Access Compliance Report

Public Rights-of-Way

(Curb Ramps)

Intersection ID: 8364	Main Street: ENGLISH_DR	Cross Street: LASALLE_ST	Location: NE
ADA ID: A78ACE4F42C5	Ramp Type: Perp	Initial Pass/Fail: Fail	Overall Compliance: No
Codes/Mitigation Info/Possible Solution			Severity Score: 10
			Field Measurements/Component Compliance

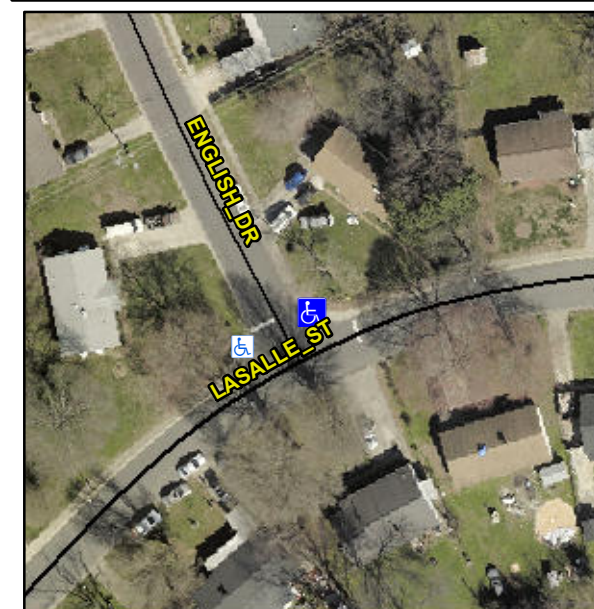
Not Found, R304.5.1, R304.5.3

Compliance	Description	Data	Compliance	Description	Data
N/A	Ramp Length (in)	58.0	Yes	Ramp Slope (%)	6.3
No	Ramp Width (in)	47.5	No	Ramp XSlope (%)	3.9
N/A	Flare Type LT	N/A	N/A	Flare Type RT	N/A
N/A	Flare Slope LT (%)	N/A	N/A	Flare Slope RT (%)	N/A
N/A	Flare Traversable LT?	N/A	N/A	Flare Traversable RT?	N/A
N/A	Landing Length (in)	N/A	N/A	DWS Provided?	N/A
N/A	Landing Width (in)	N/A	N/A	DWS Contrast?	N/A
N/A	Landing Slope (%)	N/A	N/A	DWS Length (in)	N/A
N/A	Landing X Slope (%)	N/A	N/A	DWS Full Width?	N/A
N/A	Landing Curb? (Y/N)	N/A	N/A	DWS Offset (in)	N/A
N/A	Shared Landing?	N/A			
N/A	Gutter Ponding?	N/A	N/A	Gutter Slope (%)	N/A
N/A	Gutter Lip Ht (in)	N/A	N/A	Gutter X Slope (%)	N/A
N/A	Painted X Walk1?	No	N/A	Painted X Walk2?	N/A
	X Walk 1 Direction	To SW		X Walk 2 Direction	N/A
N/A	X Walk 1 Width (in)	N/A	N/A	X Walk 2 Width (in)	N/A
	X Walk 1 Slope (%)	0.5		X Walk 2 Slope (%)	N/A
	X Walk 1 X Slope (%)	1.8		X Walk 2 X Slope (%)	N/A

Remove & Replace Entire Ramp.
